**Midway City Council  
1 March 2022  
Regular Meeting**

**The Village, Phases 1 – 3 /  
Preliminary Approval &  
Conditional Use Permit**

**CITY COUNCIL MEETING STAFF REPORT**

**Subject: The Village Development – Preliminary Review**

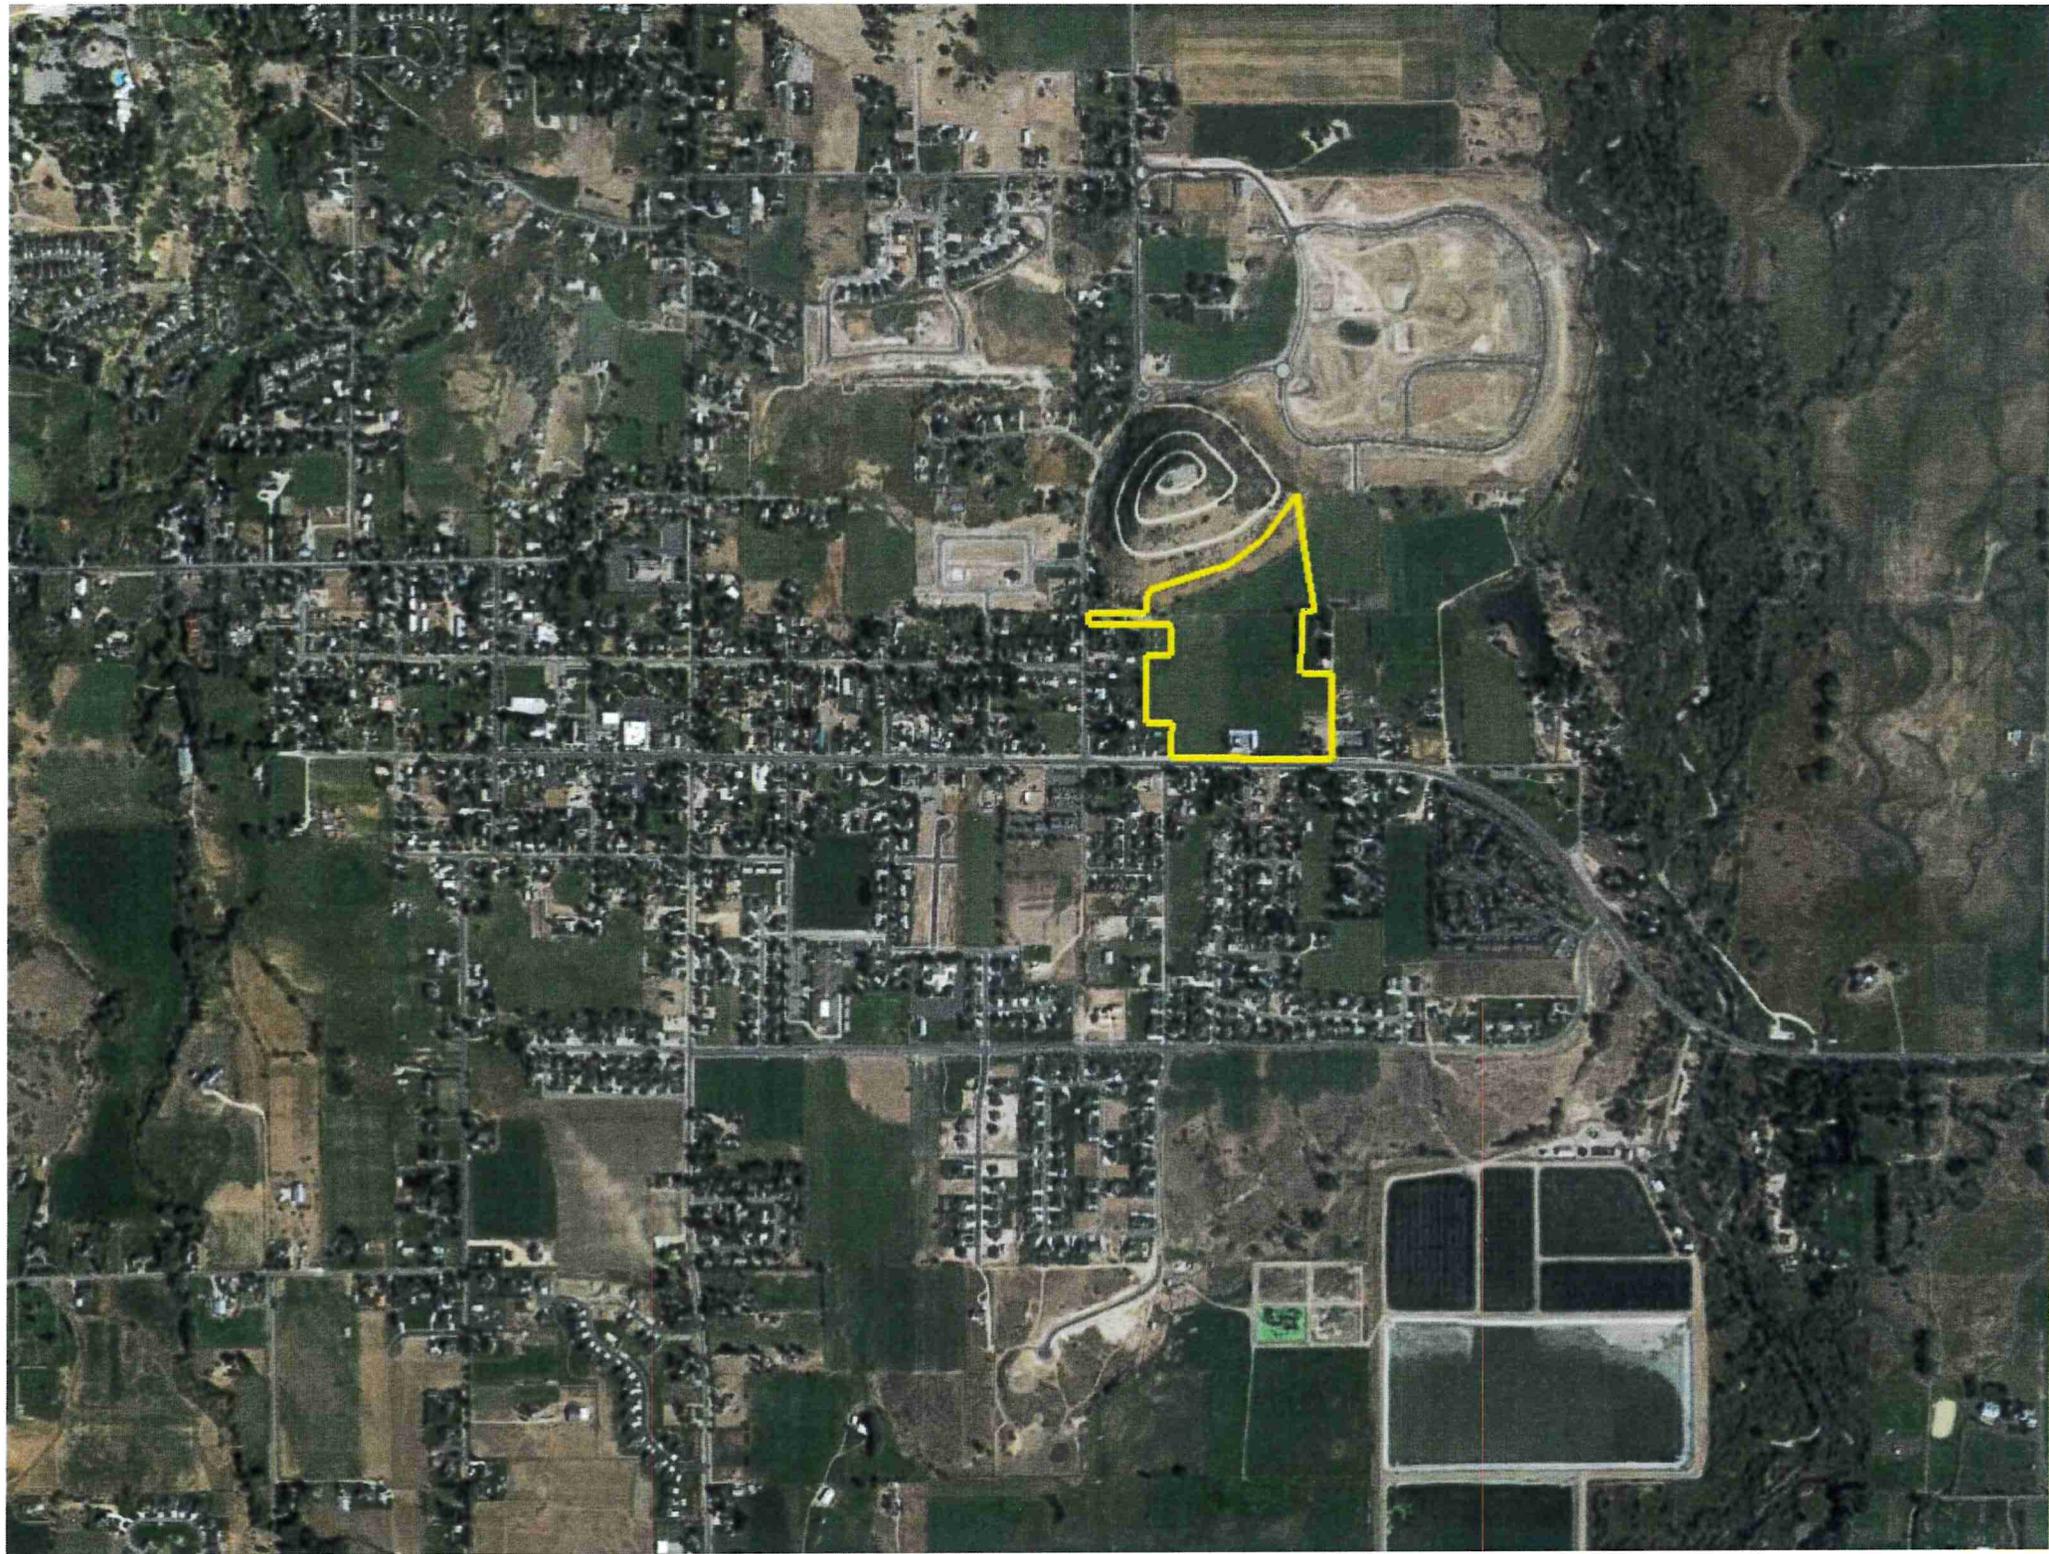
Storm Drain

- The storm drain system will be private and will be collected within the proposed curb and gutter and discharged to a series of catch basins, sumps, and detention basins with the development.
- The development will need to catch the storm water on Main Street across their frontage and pipe it to the ditch on the south side of Main Street.
- The developer should explain how possible maintenance will be done to the retention basins contained within the parking lots.
